Addendum 135 – Regulation No. 136

Amendment 1

01 series of amendments - Date of entry into force: 4 January 2023

Uniform provisions concerning the approval of vehicles of category L with regard to specific requirements for the electric power train

"Figure 1

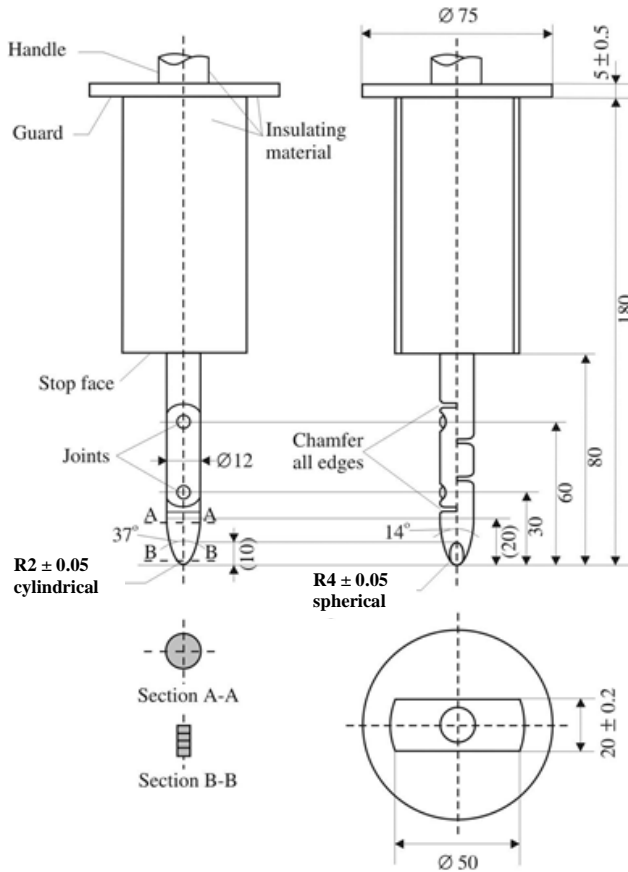
Annex 3, Figure 1, shall be deleted.

Annex 3, insert new Figure 1 to read:

Both joints shall permit movement in the same plane and the same direction through an angle of 90° with a 0 to $+10^\circ$ tolerance."

Example of Test Method using DC Power Supply

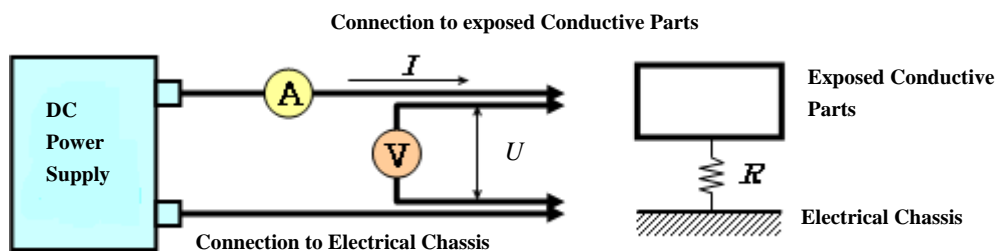
- 2.1. Test Procedure.
The DC power supply, voltmeter and ammeter are connected to the measuring points (Typically, electrical chassis and electro conductive enclosure/electrical protection barrier).
The voltage of the DC power supply is adjusted so that the current flow becomes at least 0.2 A.
The current "I" and the voltage "U" are measured.
The resistance "R" is calculated according to the following formula:
$$R = U / I$$

Figure 1
Standard Nozzle for the Test

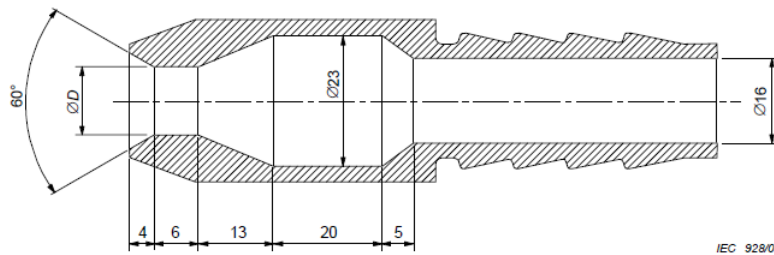
- 2.2. For electrical components, externally attached (e.g. in engine compartment), open underneath, both exposed or protected locations, the testing authority shall verify, with a view to confirming the compliance, whether the test is conducted by spraying the high-voltage component or system from all practicable directions with a stream of water from a standard test nozzle as shown in Figure 1. The following parameters are observed during the test in particular:

- (a) Nozzle internal diameter: 6.3 mm;
 - (b) Delivery rate: 11.9 – 13.2 l/min;
 - (c) Water pressure at the nozzle: approximately 30 kPa (0.3 bar);
 - (d) Test duration per m² of surface area of the tested high-voltage component or system: 1 min;

- (e) Minimum test duration: 3 min;
- (f) Distance from nozzle to tested high-voltage component or system surface: approximately 3 m (this distance may be reduced, if necessary to ensure proper wetting when spraying upwards).

Figure 2
Splashing Test Nozzle

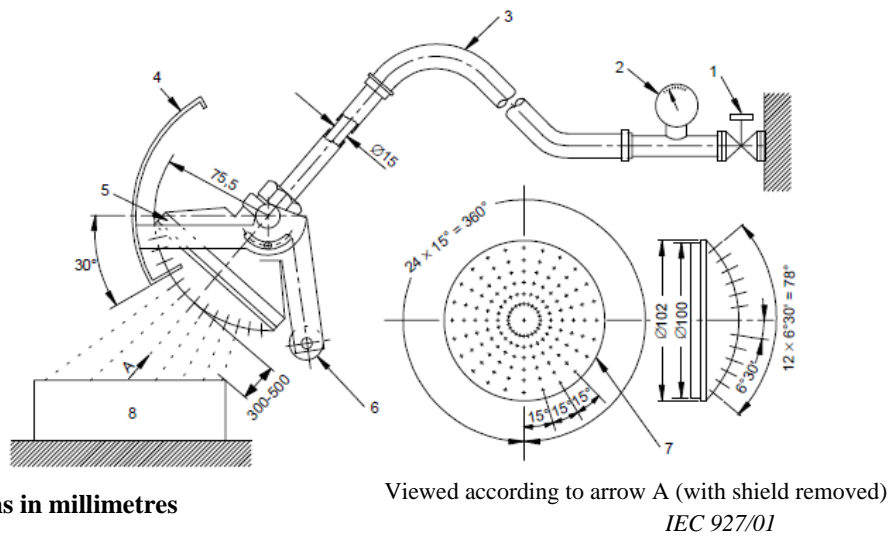
- 2.3. For externally attached electrical components (e.g. in the engine compartment), covered from underneath, the testing authority shall verify the compliance, whether:
- (a) The cover protects the component against direct spray water from underneath and is not visible;
 - (b) The test is conducted by using the splashing test nozzle as shown in Figure 2;
 - (c) The moving shield is removed from the spray nozzle and the machine is sprayed from all practicable directions;
 - (d) The water pressure is adjusted to a delivery rate of (10 ± 0.5) l/min (pressure approximately 80 kPa to 100 kPa (0.8 bar to 1.0 bar));
 - (e) The test duration is 1 min/m² of calculated surface area of the machine (excluding any mounting surface and cooling fin) with a minimum duration of 5 min.
